Docket Item # 12 A-C

West Glebe

DSUP#2006-0030

Docket Item #12 A-C
DEVELOPMENT SPECIAL USE PERMIT
2006-0031- GLEBE PARK – OLD DOMINION EAST
2006-0030 - GLEBE PARK – WEST GLEBE
SPECIAL USE PERMIT
#2007-0006 - GLEBE PARK - OLD DOMINION WEST

Fig. 11: OLD DOMINION EAST – Recommended Site Plan

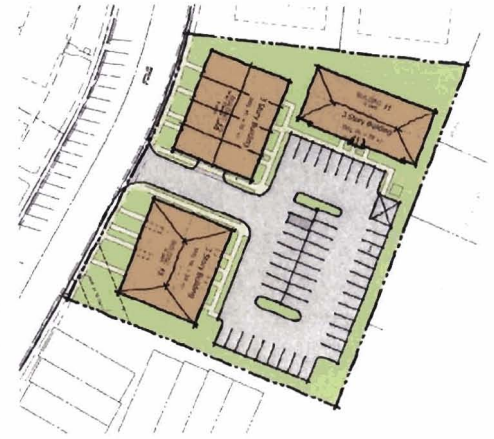
The staff recommended plan is very similar to the initial plan in layout and building design. There are some subtle differences, however, to the overall site layout and building unit types. Building #3 has remained the same with the exception that the units will be affordable workforce units. Building #2 will be entirely market rate units and will have a parking structure on the ground level. The parking structure will be screened from view by “liner” units around its exterior, similar to the buildings at Chatham Square. These “liner” units in Building #3 will have ground level entrances with internal foyers and stairways. Building #1 will not have back to back units and will have a more defined front and rear of the building.

Staff supports the revised plan, which incorporates market rate, affordable workforce units and public housing units, because it addresses many concerns that were raised by the community in that it provides a diverse mixture of economic housing types. It retains affordable public housing while providing affordable workforce and market rate units. Incorporating another economic unit types adds to the diversity of the neighborhood. Although the housing issues presented by this and the other Glebe Park cases are challenging in terms of the City's overall housing policies, staff recommends moving forward with the Glebe Park renovation and redevelopment cases in order to retain affordable housing stock and make it significantly better for ARHA residents and for the neighborhood as a whole.

Fig. 28: WEST GLEBE – Staff Recommended Parking & Open Space Design

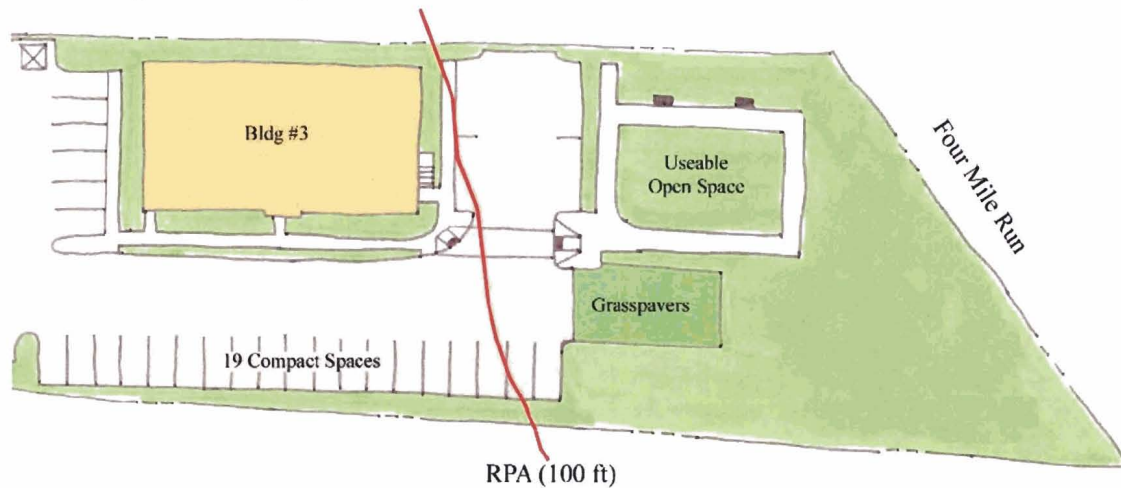
Staff has worked with the applicant to provide as much green space and buffer as possible next to Four Mile Run to ensure the future greenway and trail could be completed as part of future redevelopment of the adjoining sites. Staff has also recommended a public access easement for the area adjacent to Four Mile Run to ensure the potential future use of this property. The applicant has worked with staff to push the building farther away from Four Mile Run however there is still a considerable amount of parking proposed within the Resource Protection Area. Therefore, staff is recommending eliminating some parking spaces from the area adjacent to Four Mile Run to provide additional on-site open space, reduce the size of the proposed retaining wall, and provide a large buffer next to the stream.

The staff recommendation would result in the loss of parking spaces but would provide the additional open space, which staff believes can be justified by the parking study for the public housing units. The recommendation is an attempt to balance the parking demands and the vision of the Four Mile Run Master Plan and bring the proposal into greater compliance with the amount of open space required by the Zoning Ordinance.

Attachment 1

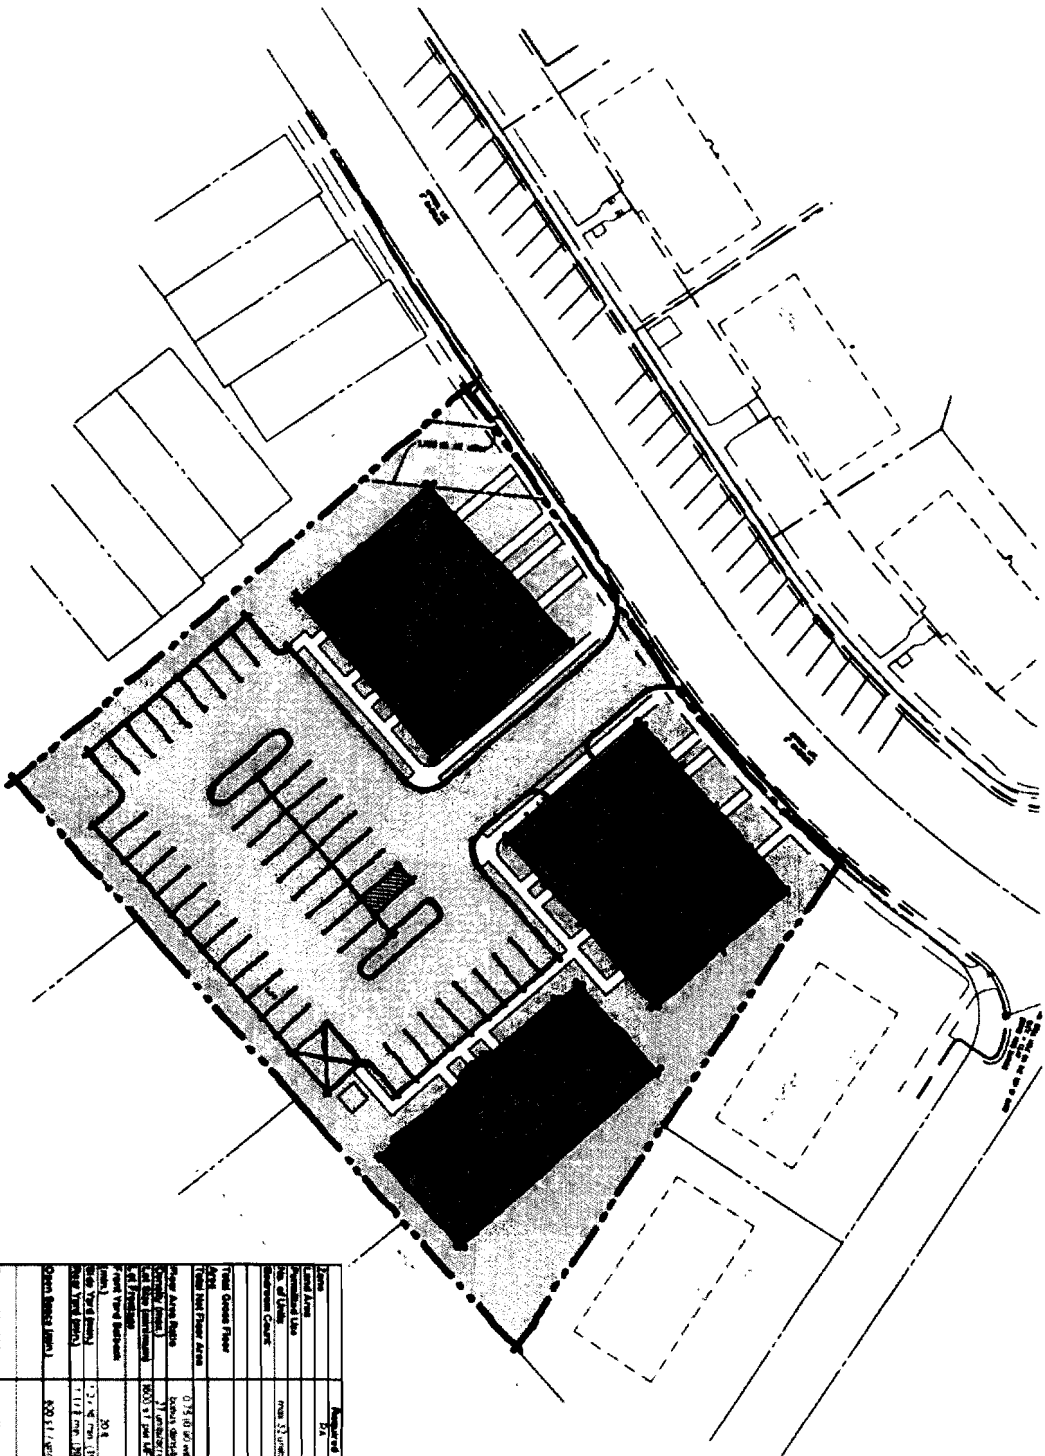
1. Revise the site layout as generally depicted in *Attachment #1*, dated September 17, 2007 and prepared by Lessard Group and shall provide the following:
 - a. Provide 30 residential units with a mix of 12 public housing units in Building #1, 10 workforce housing units in Building #3, and eight (8) market-rate units in Building #2.
